ADDENDUM NO. 01 June 24, 2025

To Drawings and Specifications dated June 10, 2025.

PKG 3A – GPHS New Fieldhouse

Prepared by:	PBK
	11 Greenway Plaza, 22 nd Floor
	Houston, TX 77046-1104
	PBK Project No: 240539

SECOND FLOOR FRAMING PLAN 1/8" = 1'-0"

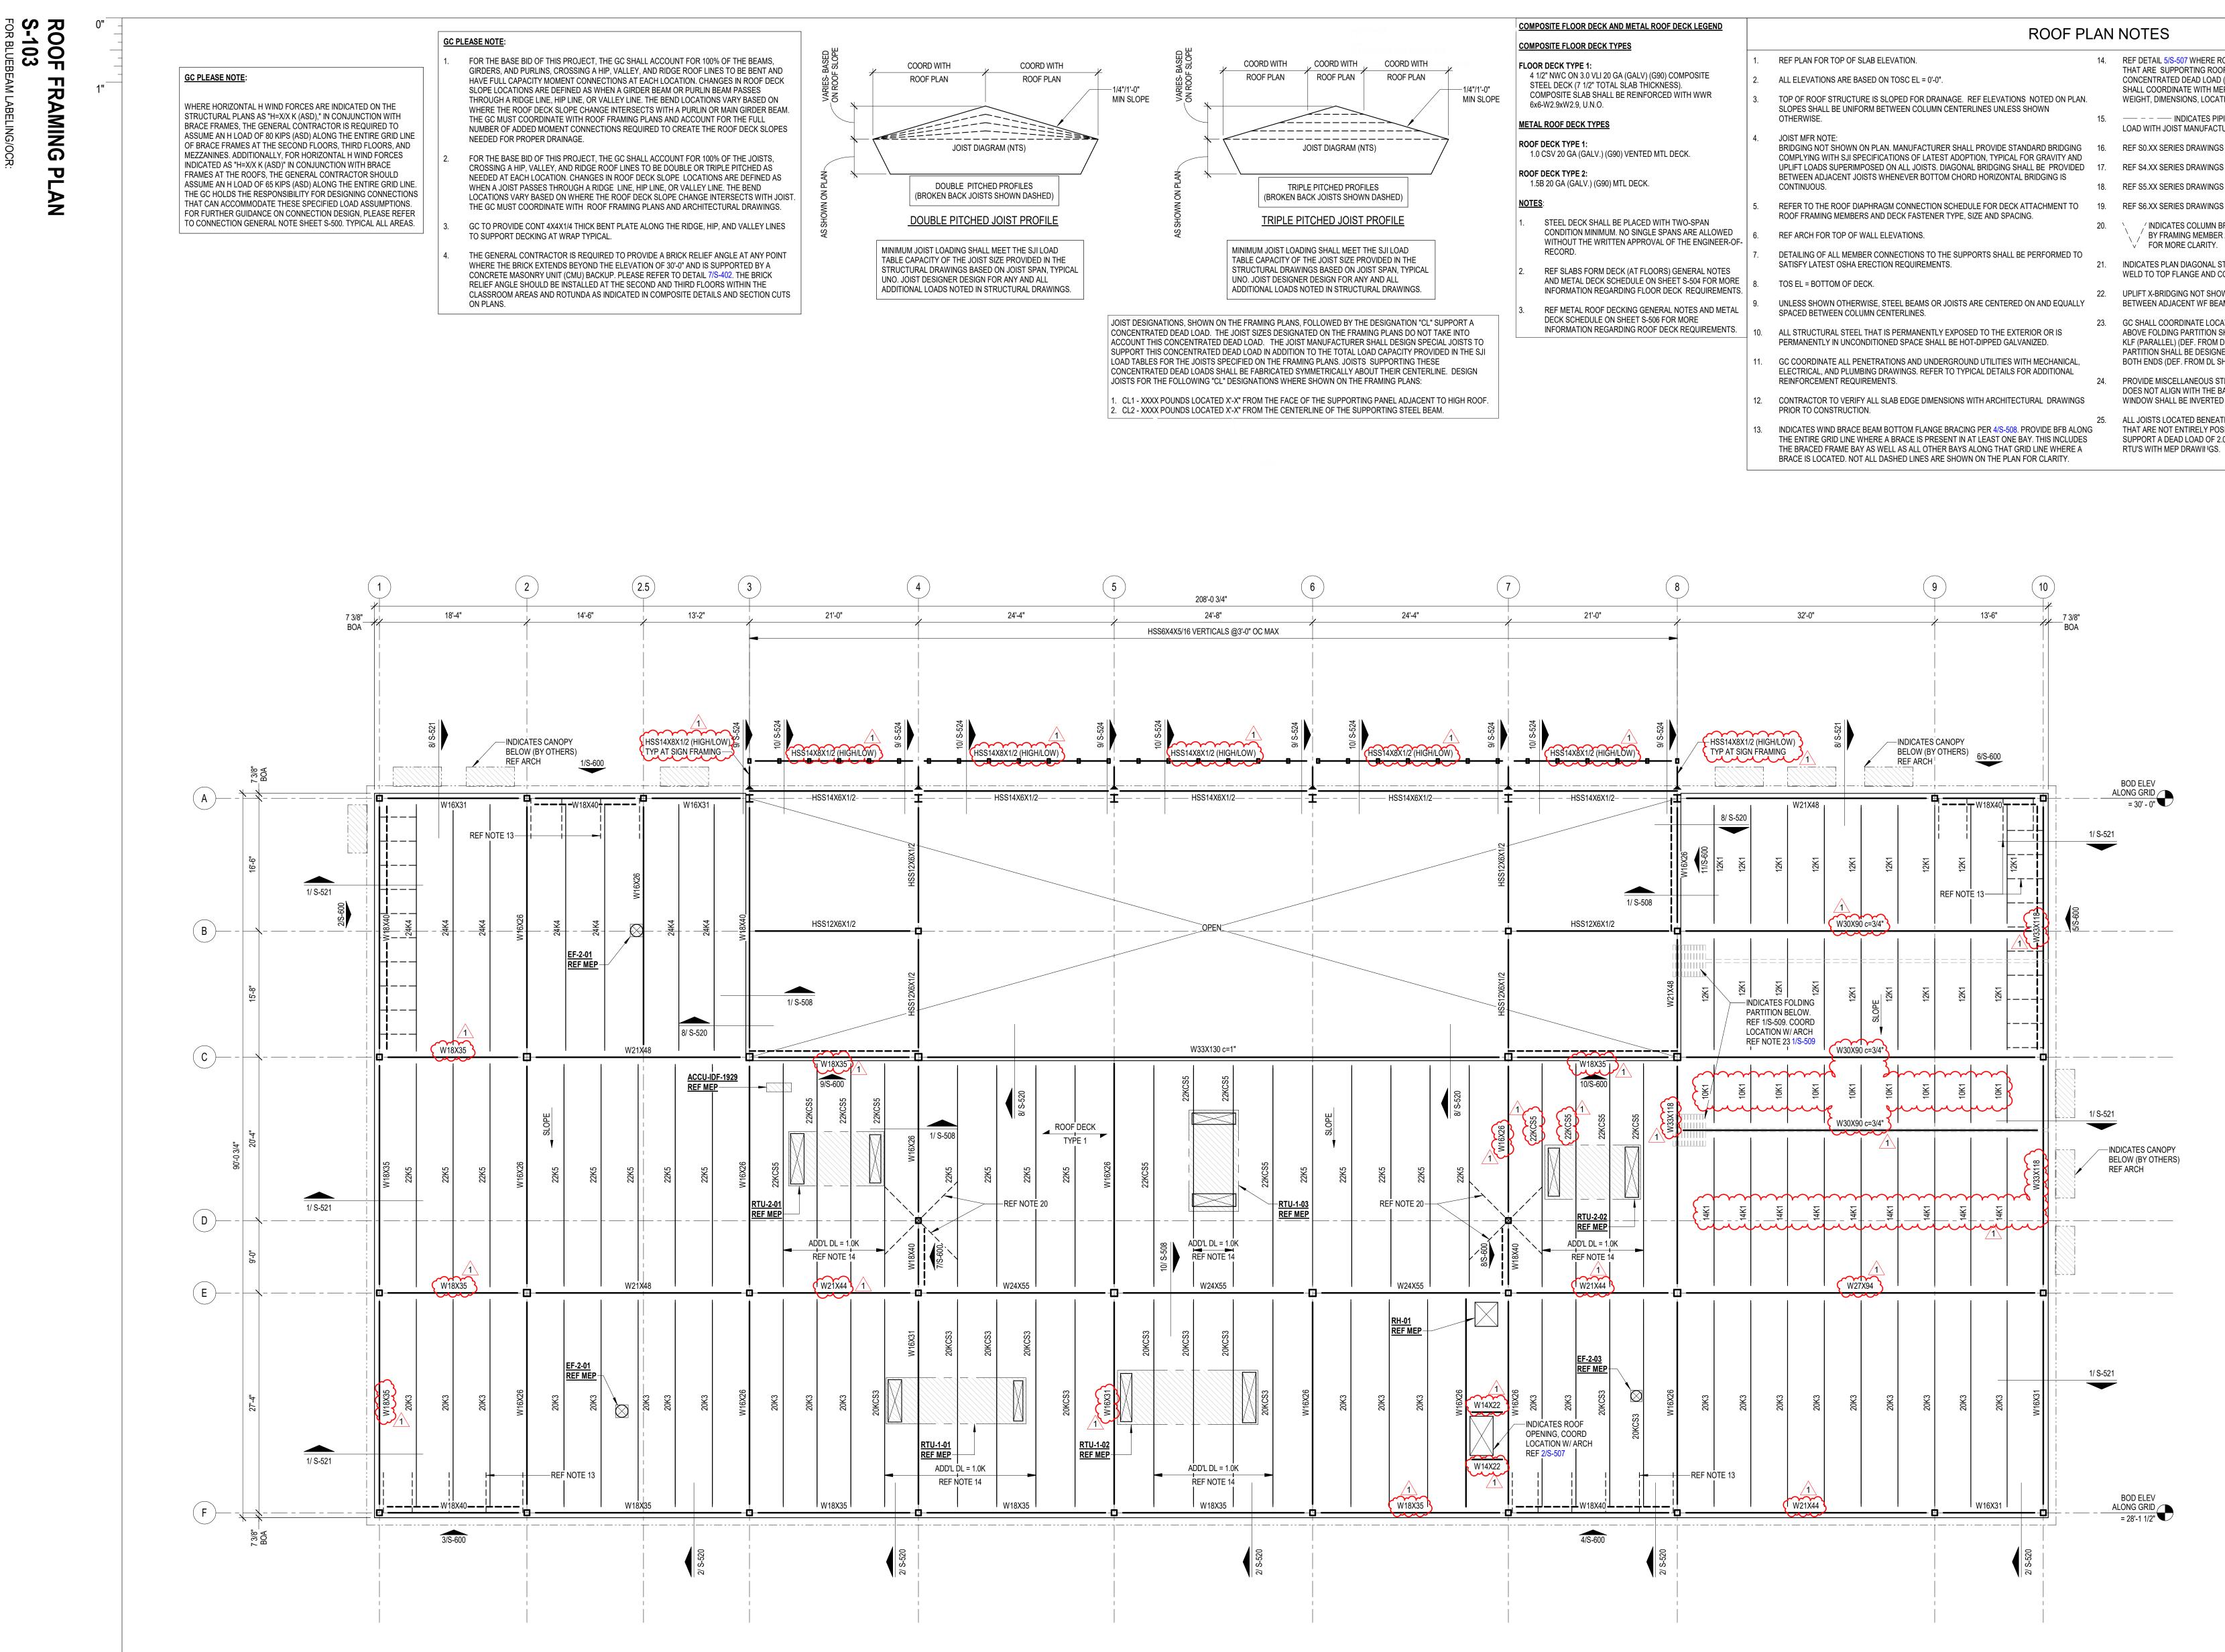
S-101 Foundation Plan
	Adjusted column sizes at A-6 and A-7.
	Adjusted footing sizes at E-5 and E-6.
	Changed section provided along grid A.
Item No. 02	S-102 Second Floor Framing Plan
Α.	· · · J · · · · · · · · · · · · · · · · · · ·
В.	· · · J · · · · · · · · · · · · · · · ·

ROOF FRAMING PLAN Λ

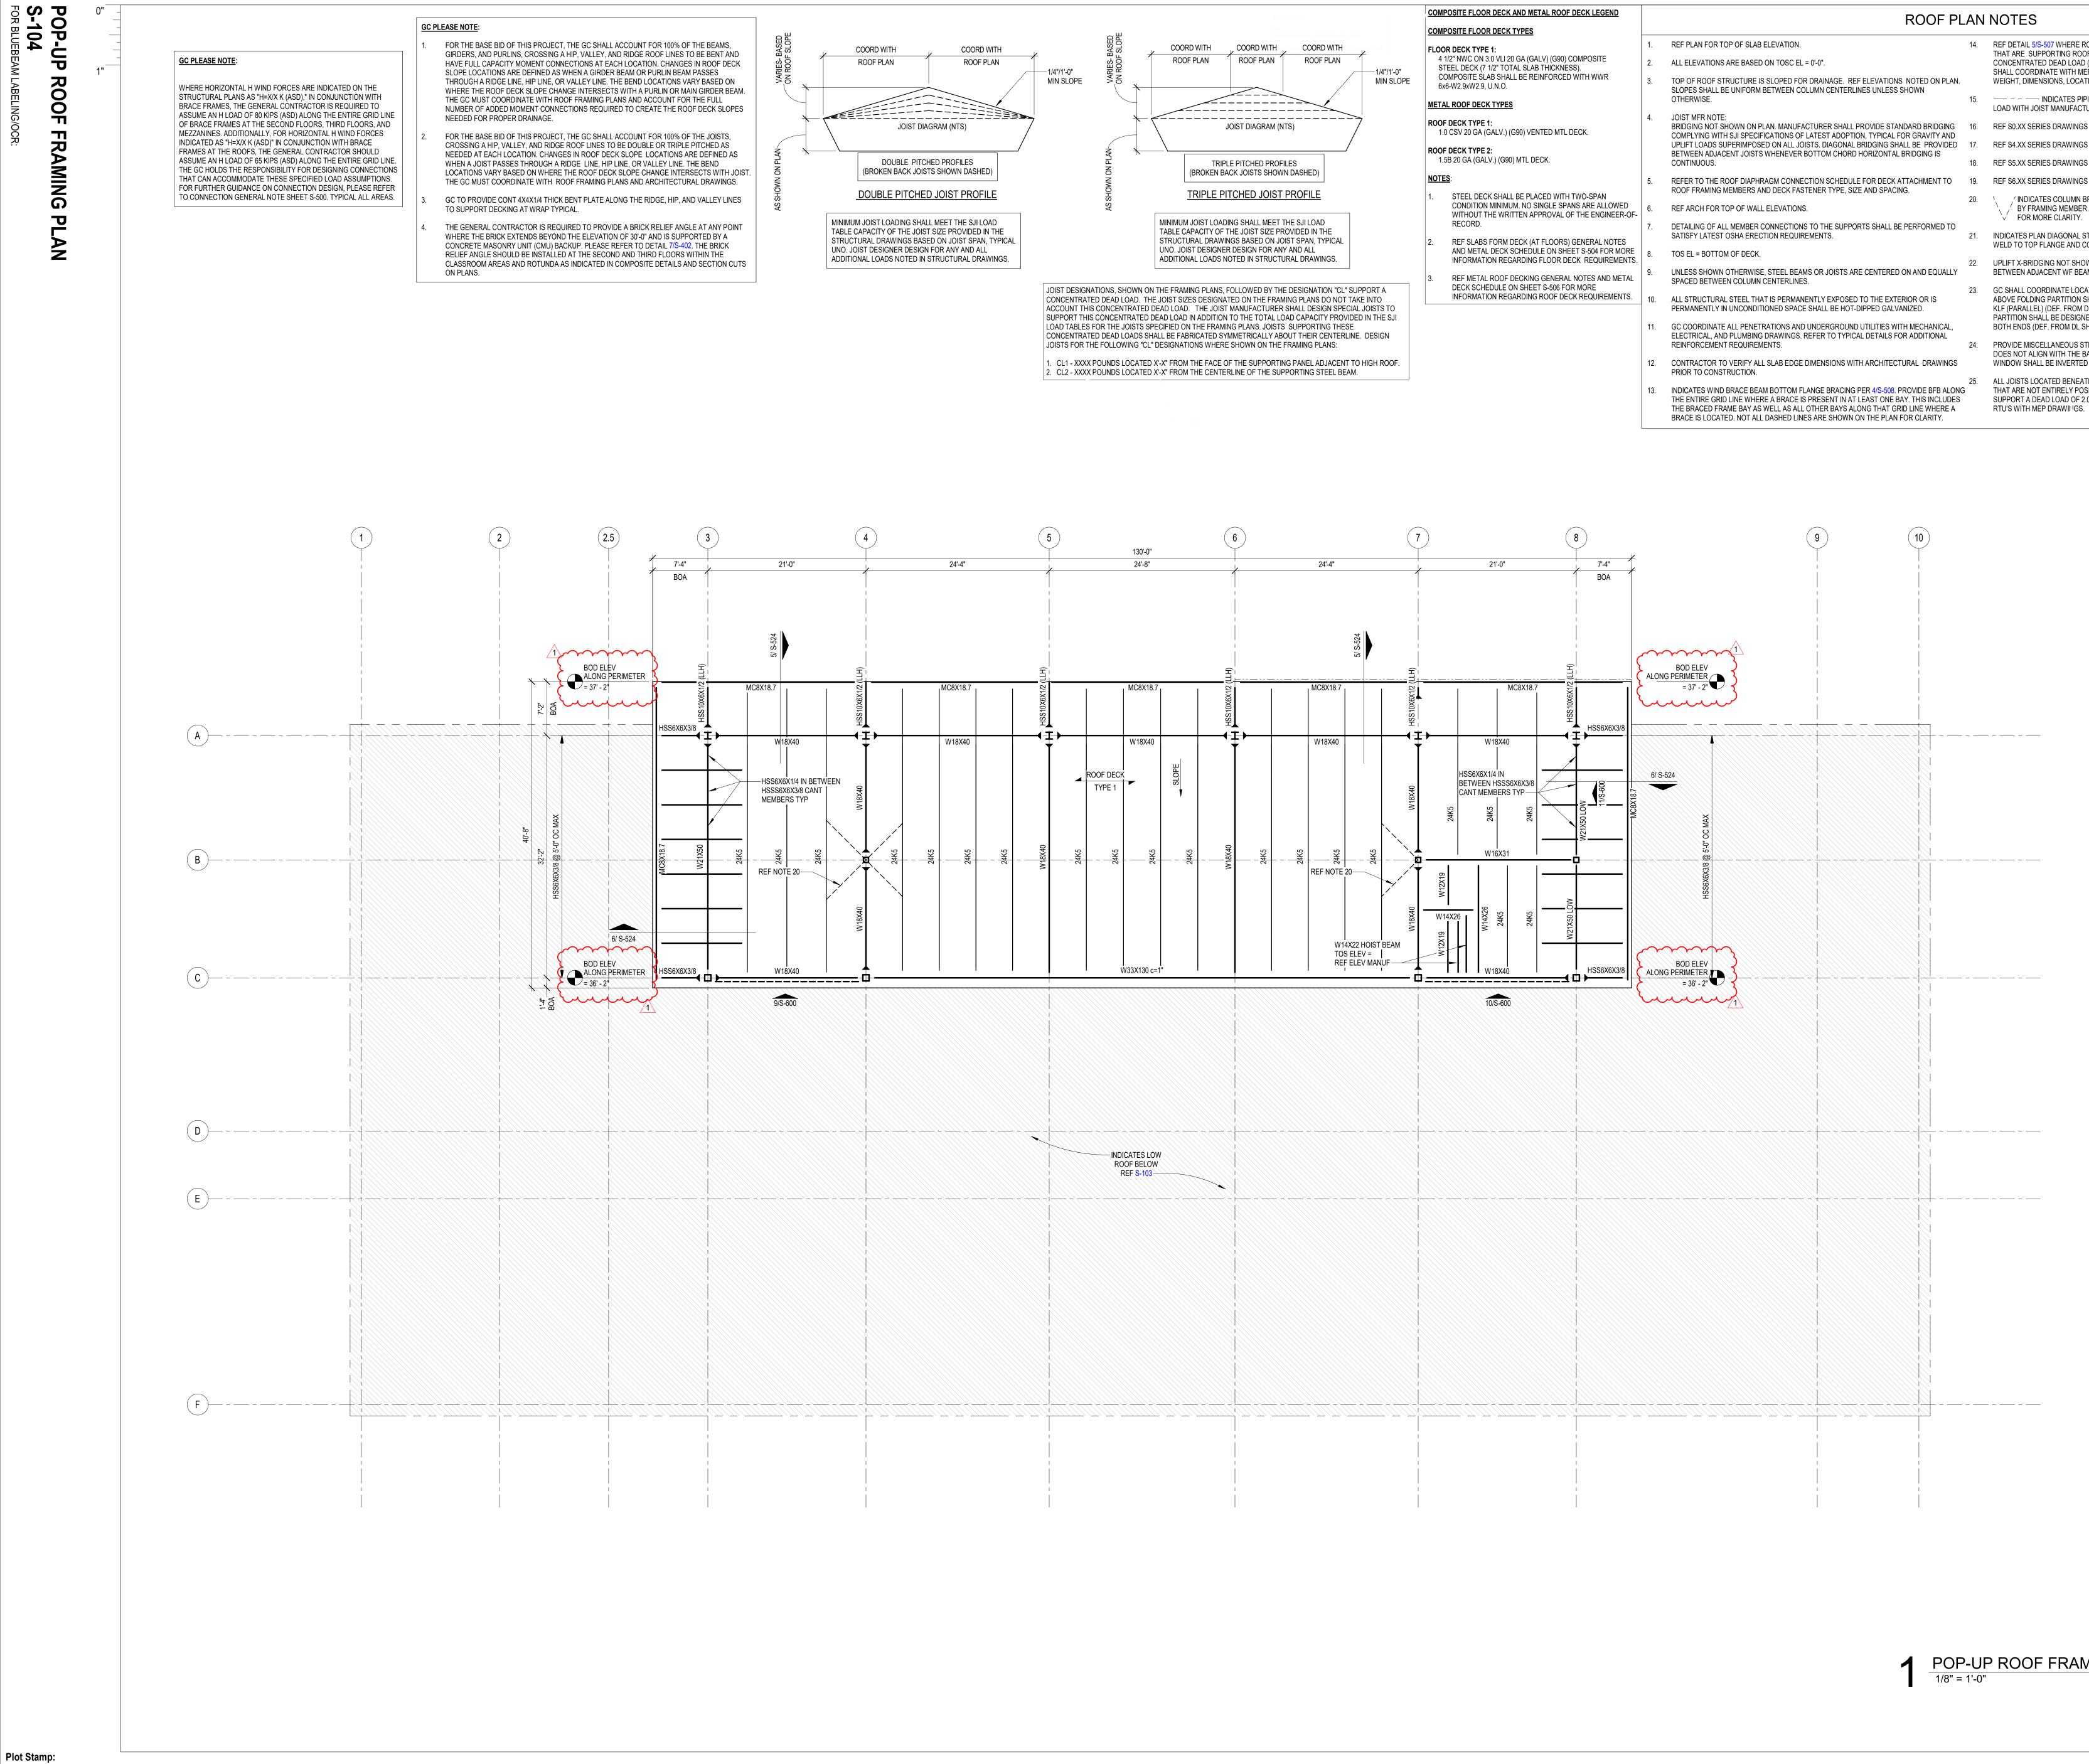
Item No. 03	S-103 Roof Framing Plan
	Adjusted beam sizes as shown on plan.
	Added camber values to beams bearing folding partitions as shown on plan.
Item No. 04	- · · · · · · · · · · · · · · · · · · ·
	Provided BOD elevations along perimeter.

1 FLOOR PLAN DW-100.7

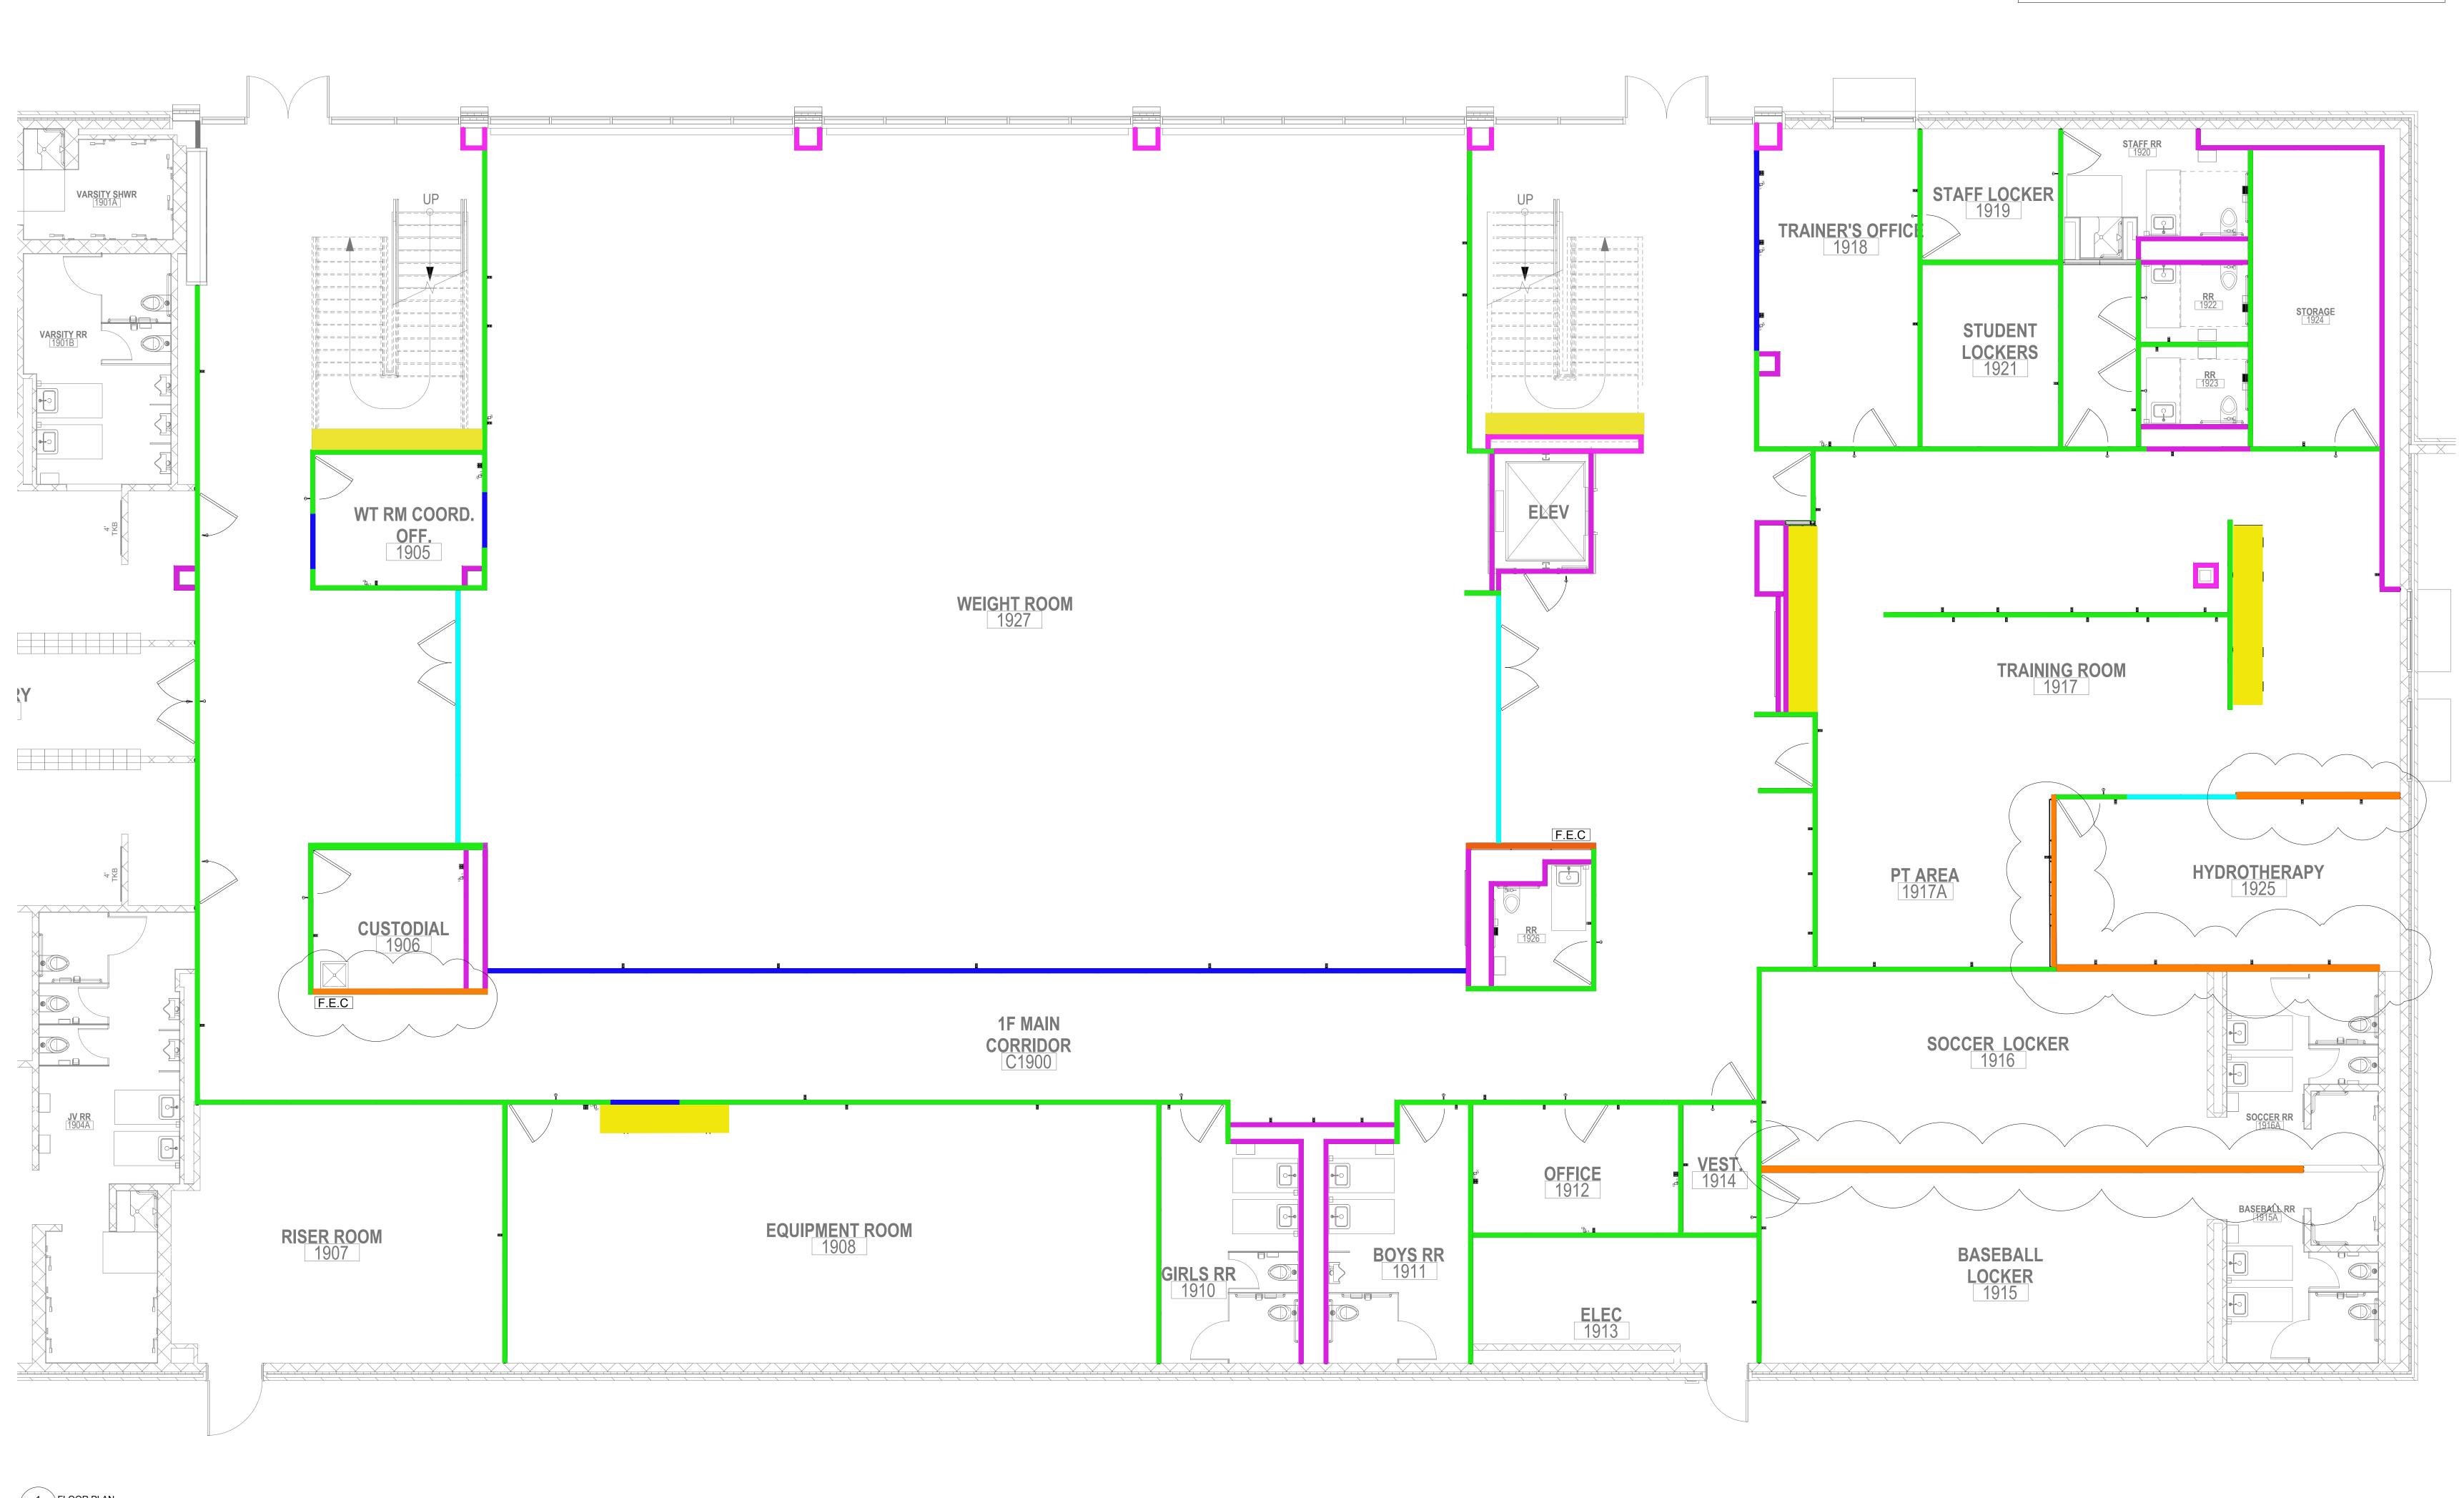
ltem No. 01	DW100.7 HIGHLIGHTED PLAN FIRST FLOOR
А.	DIRTT walls thickness changes from 4" to 6" thick
ltem No. 02	DW100.8 HIGHLIGHTED PLAN SECOND FLOOR
А.	DIRTT walls thickness changes from 4" to 6" thick
ltem No. 03	DW400.1 TYPICAL WALL DETAILS
А.	Typical wall section for 4" and 6" DIRTT walls were added
